Sport Mode Cruise Control Logic Improvement

Service Category Engine/Hybrid System

Section Cruise Control

YEAR(S)	MODEL(S)	ADDITIONAL INFORMATION
2019	Corolla Hatchback	VDS(s): K4RBE Engine(s): M20 Transmission(s): CVT

Figure 1. Location of Authorized Modifications Label on 2019 Corolla Hatchback

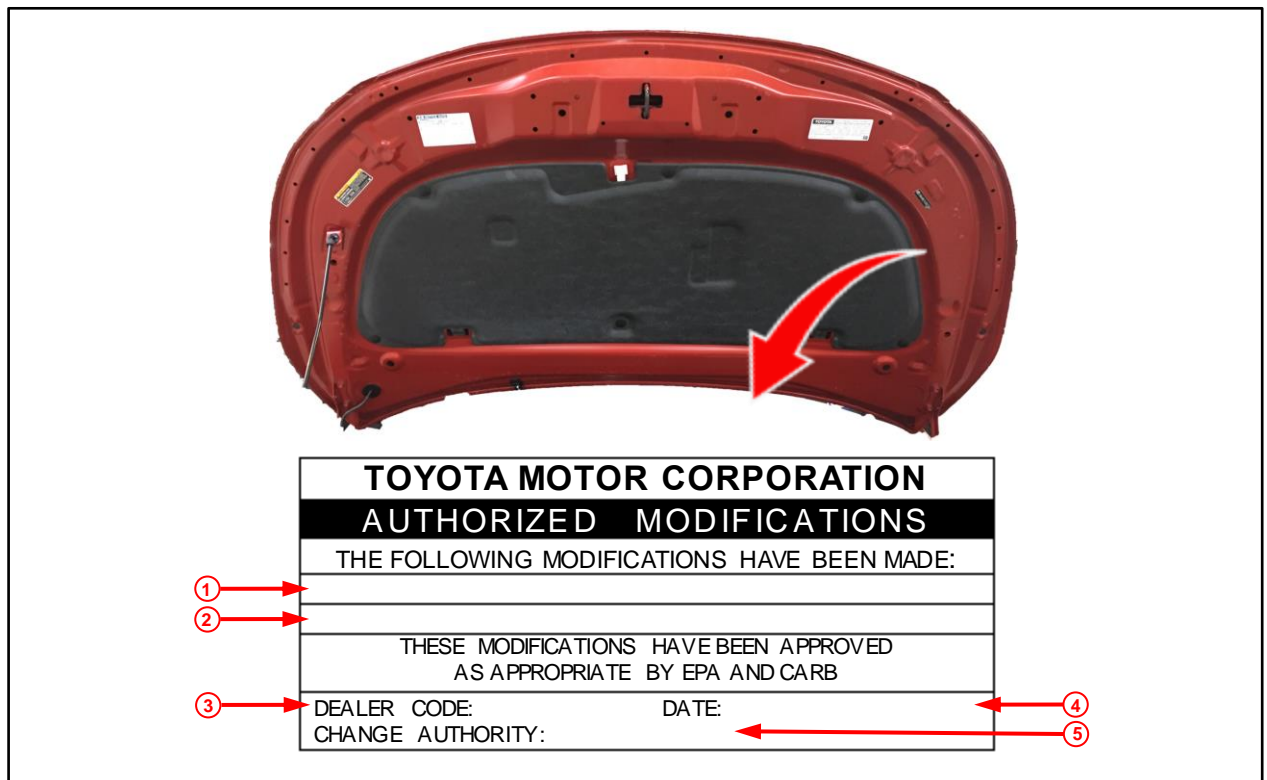
- Check for the Authorized Modifications Label affixed to the vehicle in the location shown below. Confirm if the ECM (PCM) calibration has been updated.

B. Install the Authorized Modifications Label onto the vehicle at the location shown in Figure 1. The Authorized Modifications Label is available through the MDC, P/N 00451-00001-LBL.
